Application to amend a progressive rehabilitation and closure plan schedule (PRCP schedule) or joint PRCP schedule and environmental authority

Section 1 – Environmental authority and PRCP schedule number	
Environmental authority number this PRCP schedule relates to.	EPML00744813
PRCP schedule reference number.	P_PRCP_100807509

The amendment proposes the expansion of the authorised disturbance footprint by 98.6 Ha, which is a 1.6 Ha increase to the approved disturbance footprint of 6105 Ha. The additional disturbance area is for:
- a realignment of the Eagles Nest levee,
- a new Mine Infrastructure Area.
- to demonstrate the authorisation of disturbance to fire trails surrounding the mining leases for fire management; and
- to address clerical administrative errors to the mining lease boundaries identified within Figure 1.

Figure 4: Eagles Nest Levee proposed disturbance area

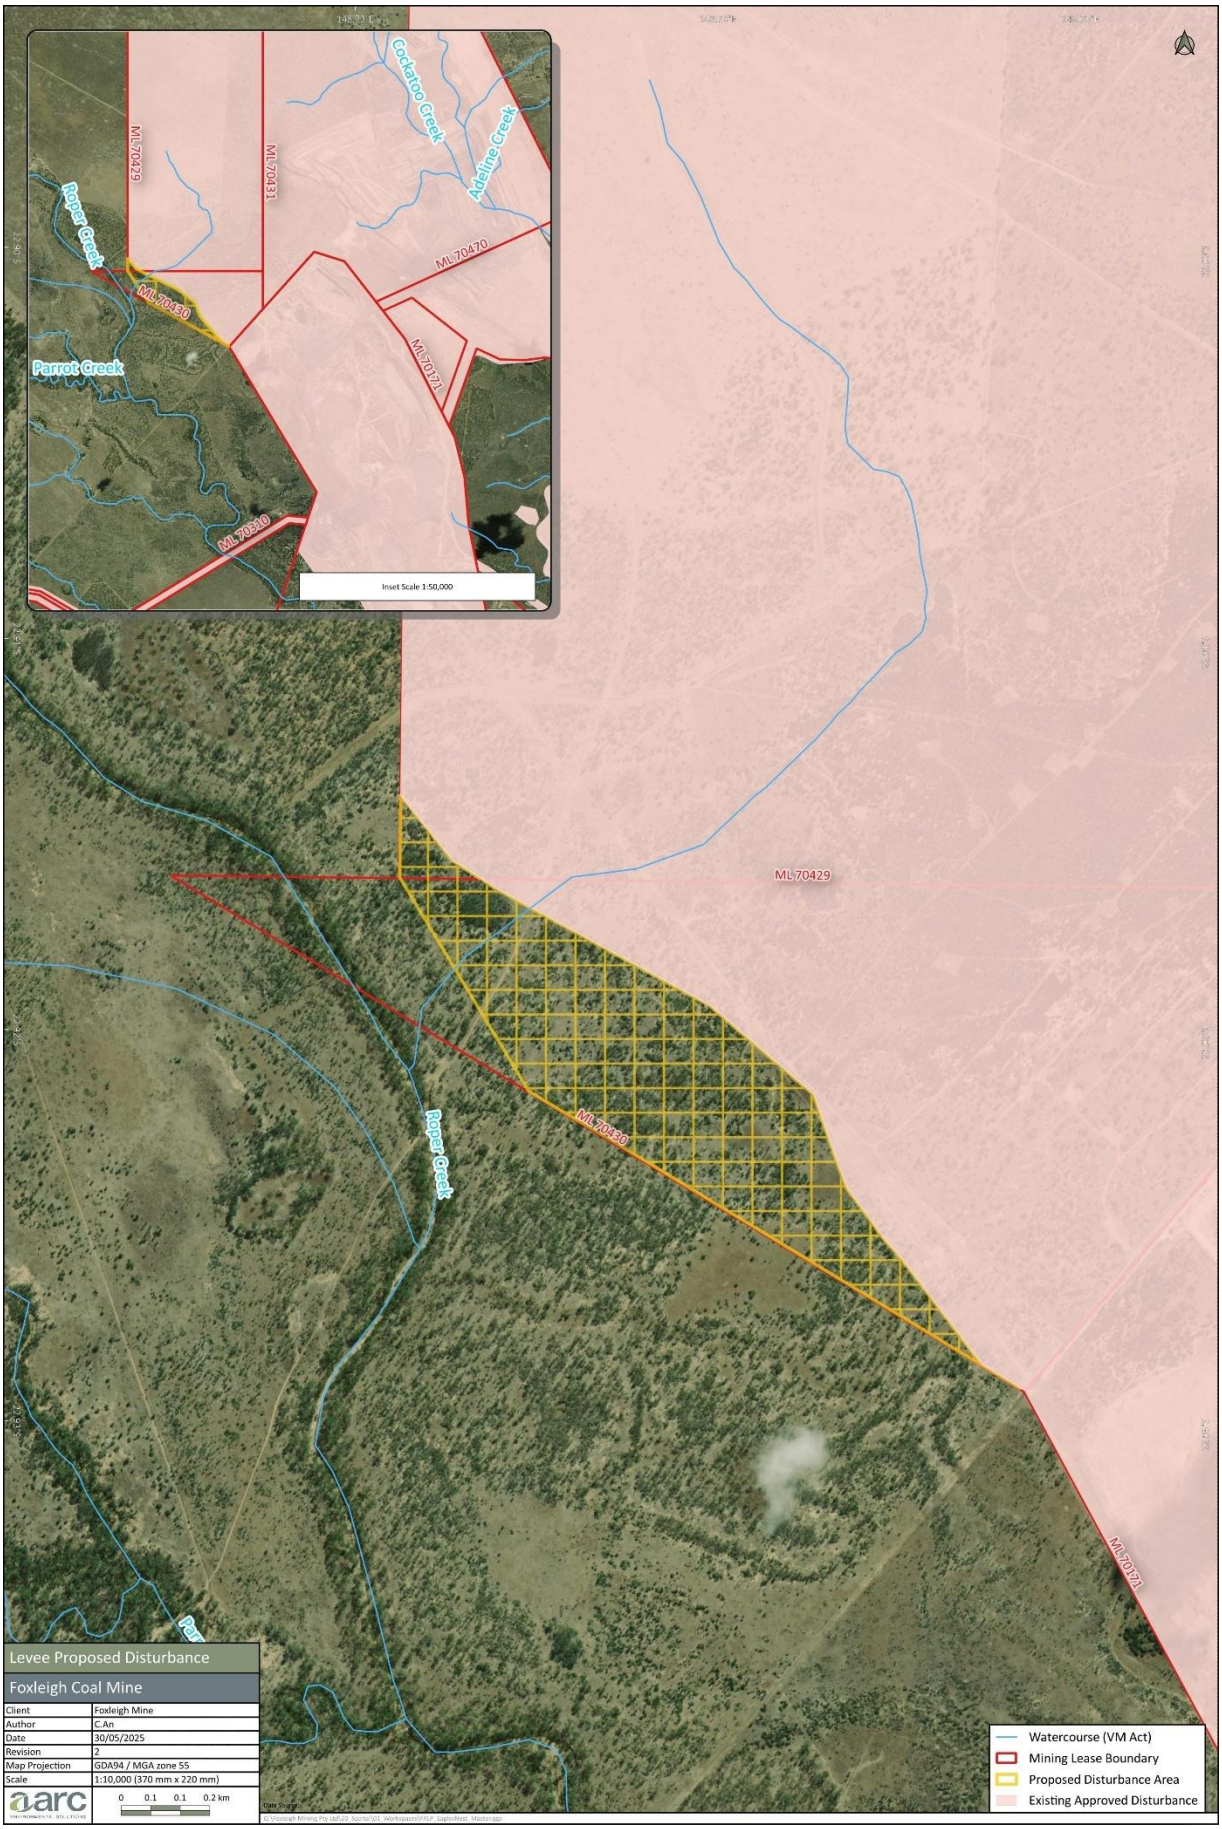
Furthermore, on completion of the levee design and assessment of impacts, if required, a secondary amendment application will be made to the PRCP to address the changes to the location of RA8 – Flood Protection Landform, any other secondary changes to RAs, as a result of the project.

Figure 6: North MIA proposed disturbance area

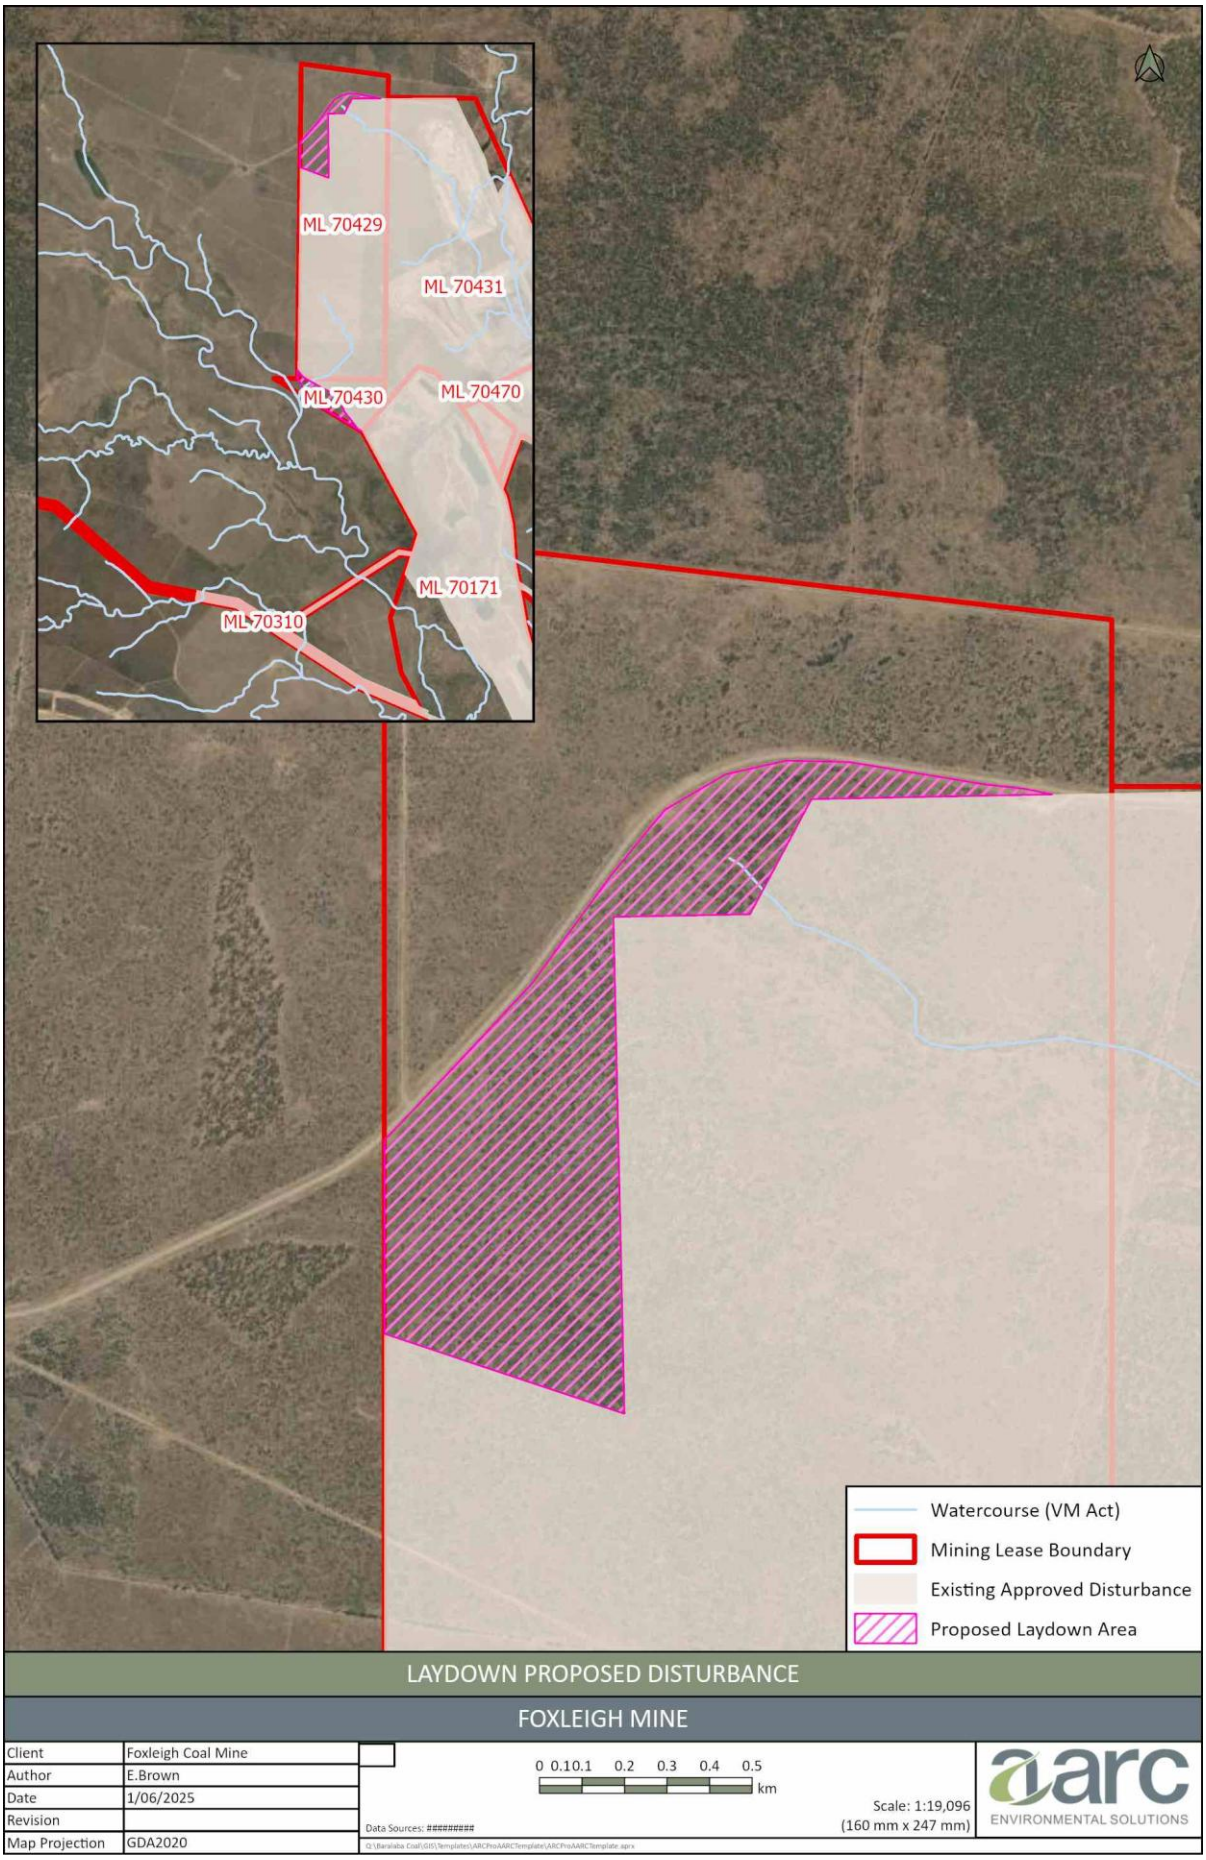
The proposed re-alignment of the North MIA as depicted in

Figure 6, is slightly north of the existing mine activities and south of the Barwon Park Middlemount Road. This amendment application proposes an additional disturbance area of 66 ha to accommodate for this facility.
